# DE HAVILLAND SERVICE

## TECHNICAL NEWS SHEET

### INDEX series V (Vampire Airframe, General Circulation)

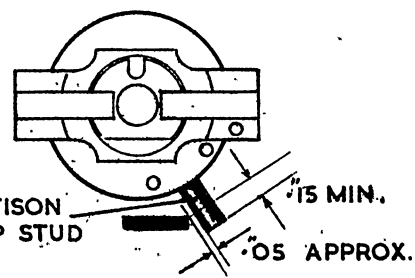
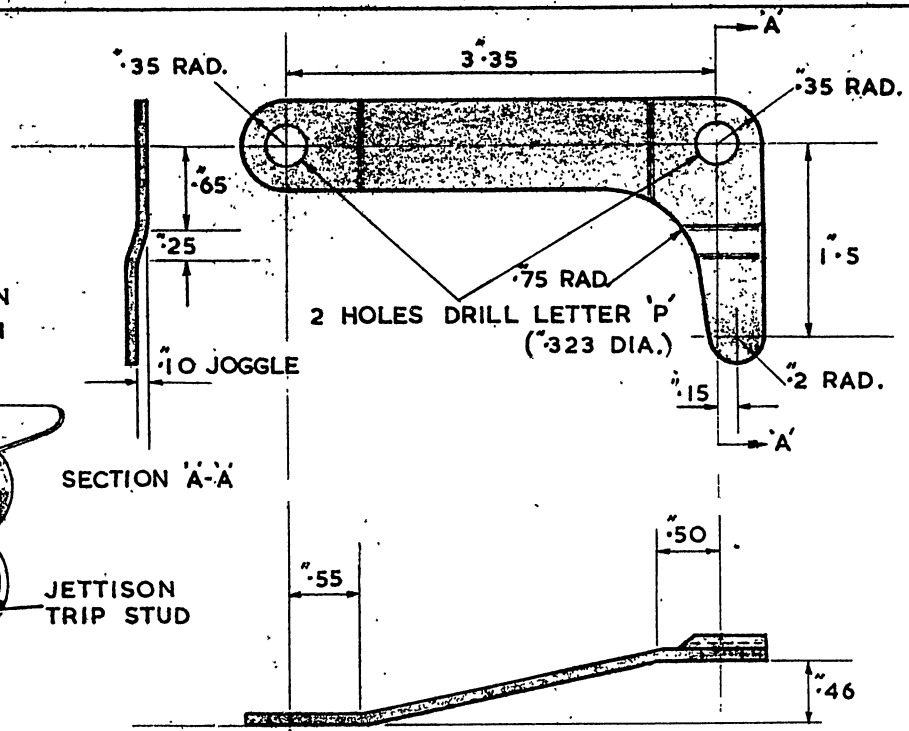
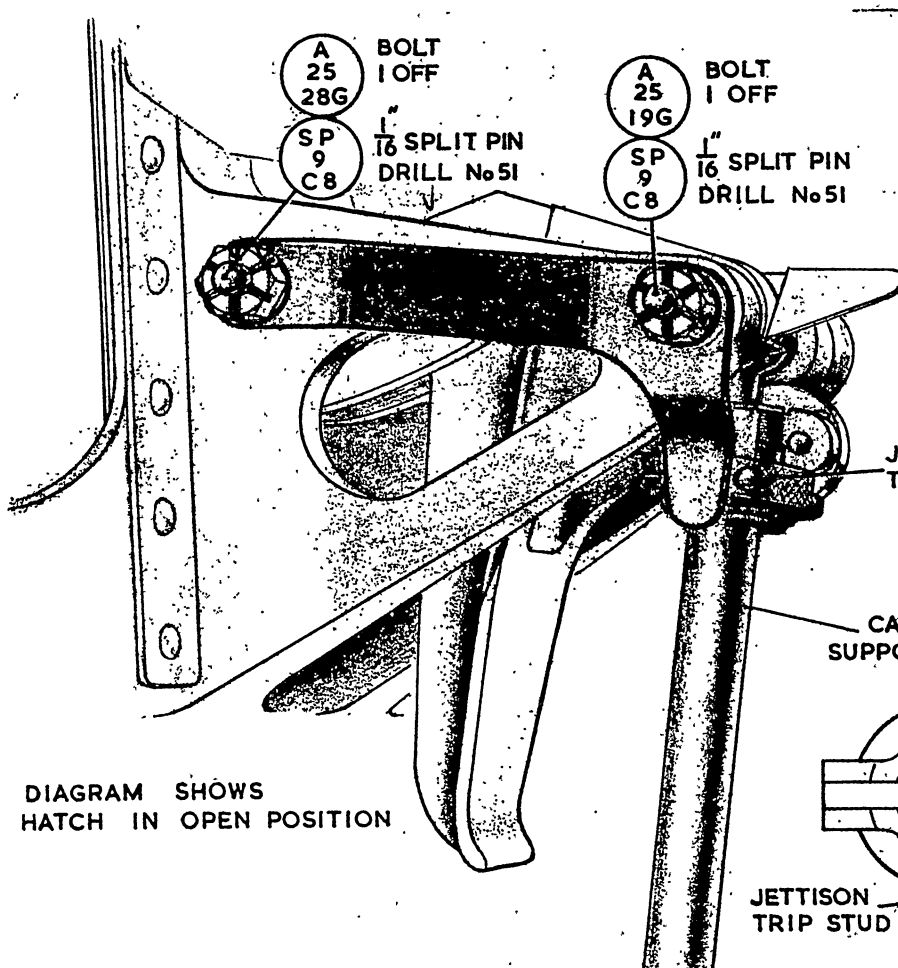
4. Assemble the new jettison guard as shown on the Drawing and refit existing castle nuts and washers.
  5. Drill No. 51 split pin hole in each bolt and **re-split pin.**

APPLICABLE TO PREFABRICATED HATCH ONLY  
 INTRODUCED ON MOD VAMPIRE 3151

MAKE FROM 14 SWG ALCLAD L72  
 FINISH IN ACCORDANCE WITH  
 RELEVANT PUBLICATIONS

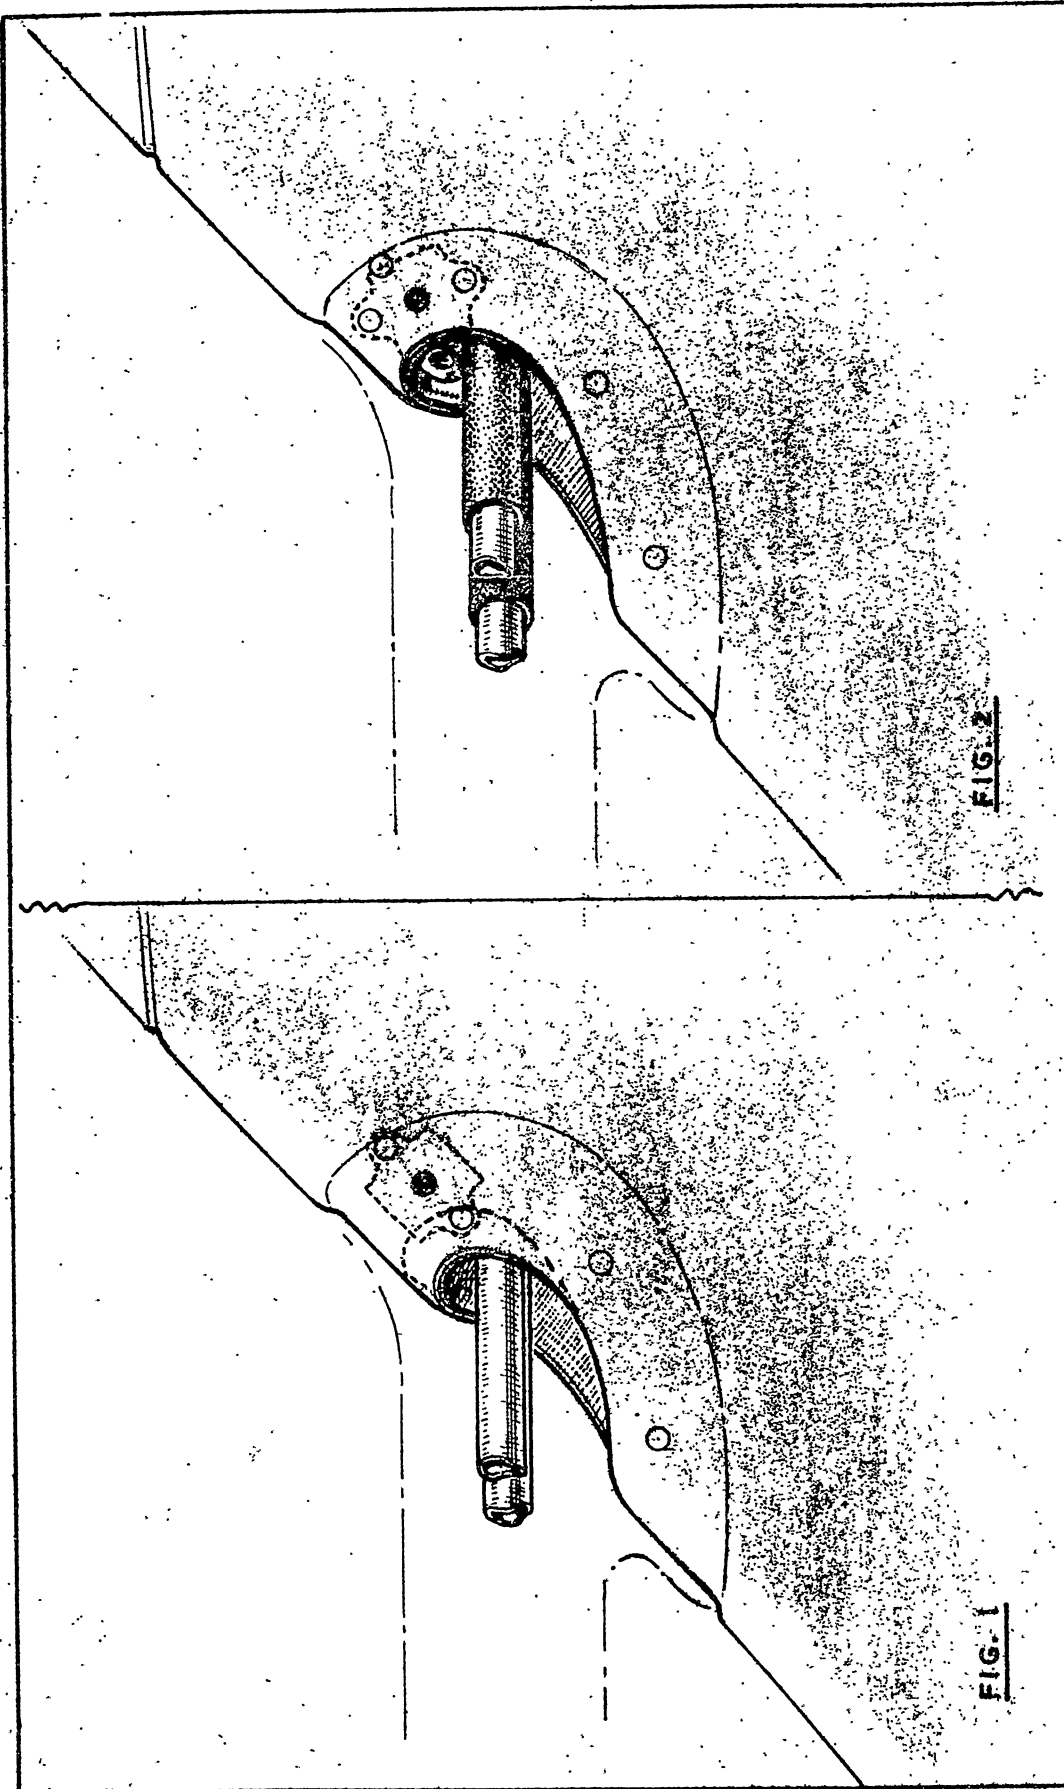
- (b) Examine the top two 4B.A. anchor nuts shown on ( Drawing ROOJ.75 attached) and if they are found to be secured as shown in fig.1. they are to be removed and rotated on their existing centre to the positions shown in fig.2. This is with their straight edge parallel to the fins of the joggle in the fin skin.
- (c) Cut the top half of the aperture back to the edge of the top anchor nuts and blend it with the lower half. Radius the edges and apply protective treatment.
- (d) Slide on over each pipe approximately two inches of protective sleeving. Sisto-flex or any suitable dimensioned rubber tubing may be used. The tubing to be positioned to provide protection for the pipes through the aperture.
- (e) Re-assemble the pipe connections and pitot head and test the system as laid down in the relevant publication.

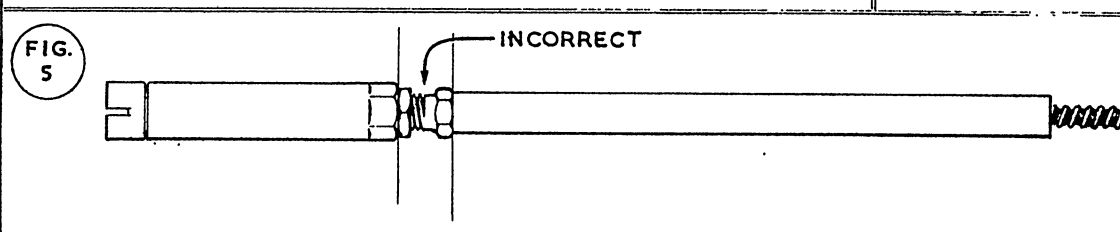
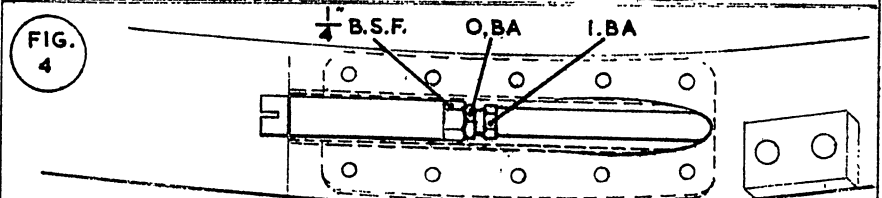
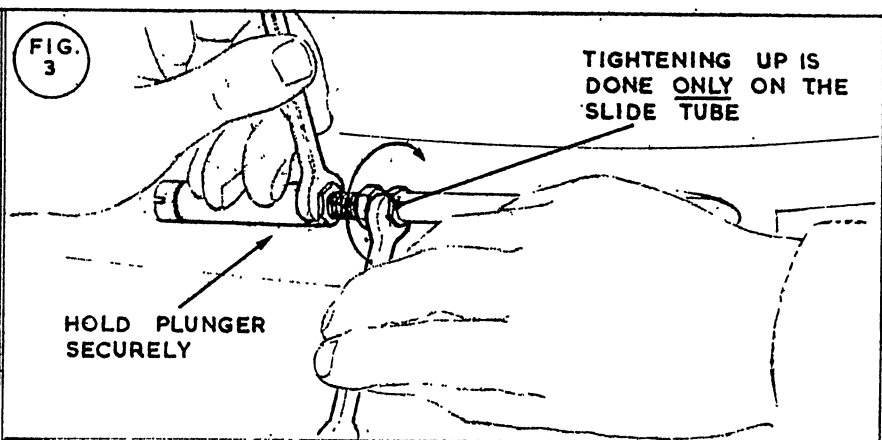
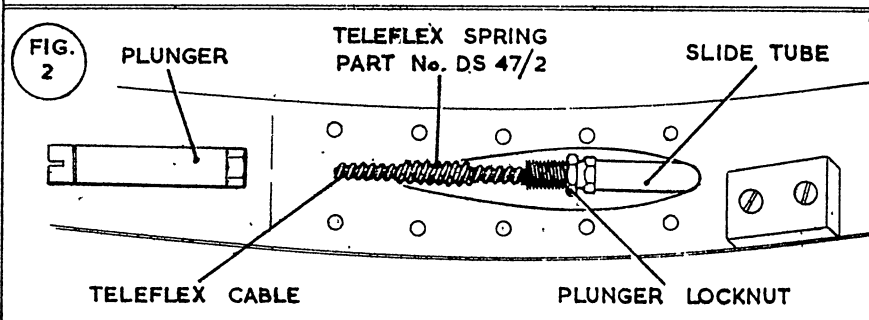
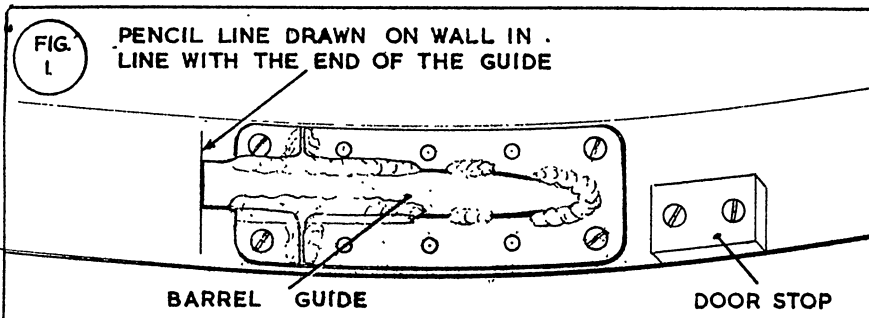
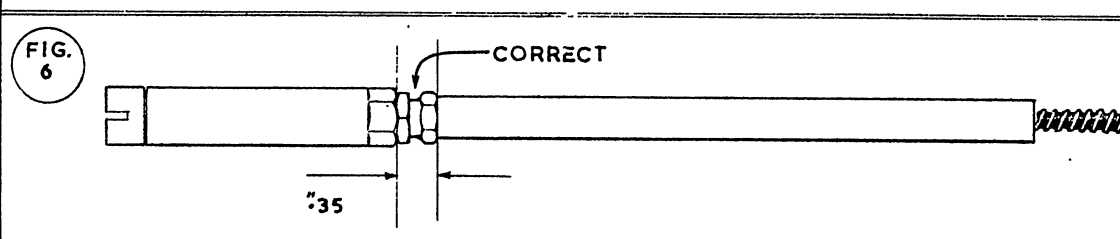
6. Remove the plunger assembly, fit a new lock spring Teleflex Part No. DS.47/2 (Note lock spring should be used once only). With the teleflex pulled out to its full extent, adjust the position of the spring so that when the plunger is replaced against the spring, the groove on the plunger is approximately 1/32" in advance of the pencil line (see fig.2)<sup>1</sup>/<sub>2</sub>

IT IS NOT SUFFICIENT TO SCREW IN THE SLIDING TUBE UNTIL THE SPRING IS FELT, (AS SHOWN IN FIG. 5) BUT KEEP SCREWING UNTIL IT IS NOT POSSIBLE TO COMPRESS THE SPRING FURTHER. DIMENSION .35 MUST BE OBTAINED. (FIG. 6)

**IMPORTANT**  
IF THE LOCK SPRING ADJUSTMENT IS ALTERED OR IT IS REMOVED DURING SERVICING IT IS ESSENTIAL TO FIT A NEW LOCK SPRING TELEFLEX PART No. DS 47/2

ROOG 49

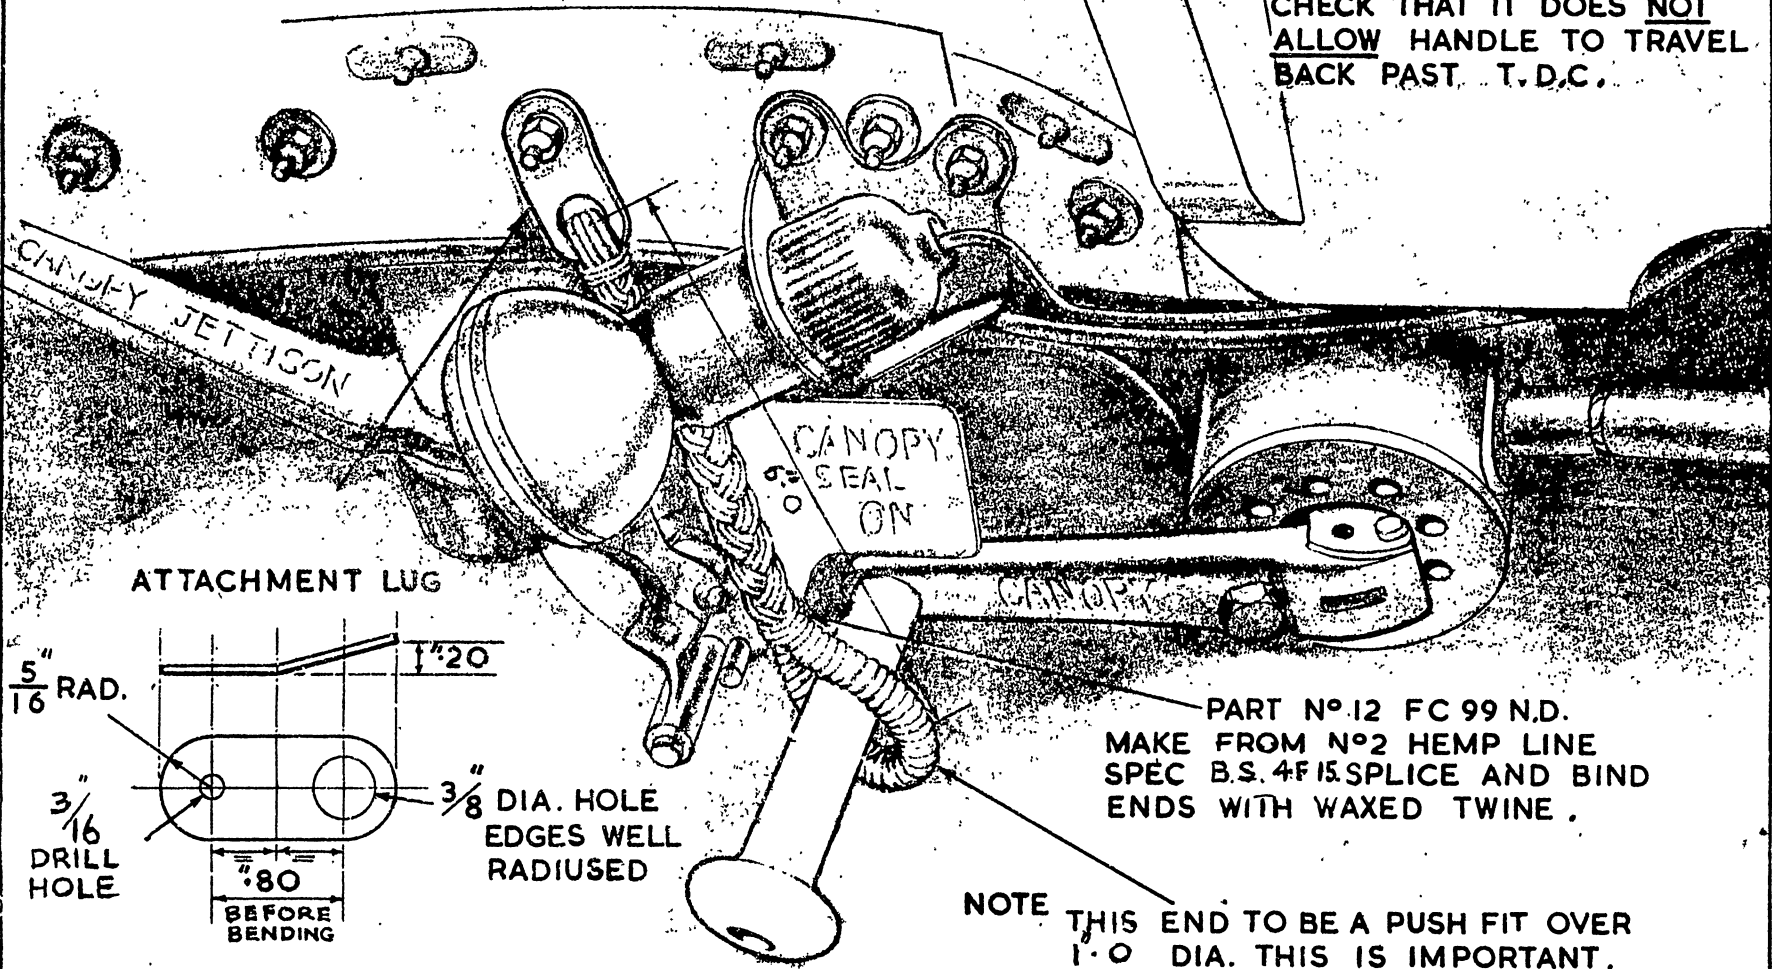
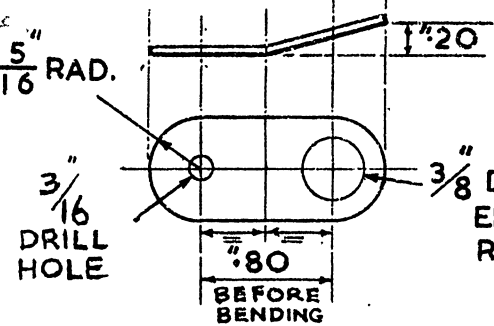
- A. Special Technical Instruction/Vampire/133.  
Canopy Winding Handle: Provision of Lanyard.
- B. Vampire Mk.s 3, 5, 9. Sea Vampires Mk.20 and Mk.21.
- C. Cases have been reported of the canopy opening in flight, due to the locking pin in the handle coming out of its hole in the micrometer locking plate. The purpose of this instruction is to provide a lanyard to prevent the handle unwinding in flight.
- D. At or before the next Primary Star Servicing proceed as follows:-
  1. Ensure the canopy winding gear is correctly rigged to S.T.I.Vampire 68A.
  2. Refer to (attached Drawing R.12.FC.101) and make up the lanyard and lug as specified. Fit the lanyard/lug assembly to the existing canopy rail bolt, which is the 8th bolt visible aft of the wind-screen member above the canopy seal cock. The lanyard should be forward of the cockpit light and should not rest on the top.

WHEN LANYARD IS FITTED  
CHECK THAT IT DOES NOT  
ALLOW HANDLE TO TRAVEL  
BACK PAST T.D.C.

PART NO 12 FC 99 N.D.  
MAKE FROM NO 2 HEMP LINE  
SPEC B.S. 4F15. SPLICE AND BIND  
ENDS WITH WAXED TWINE.
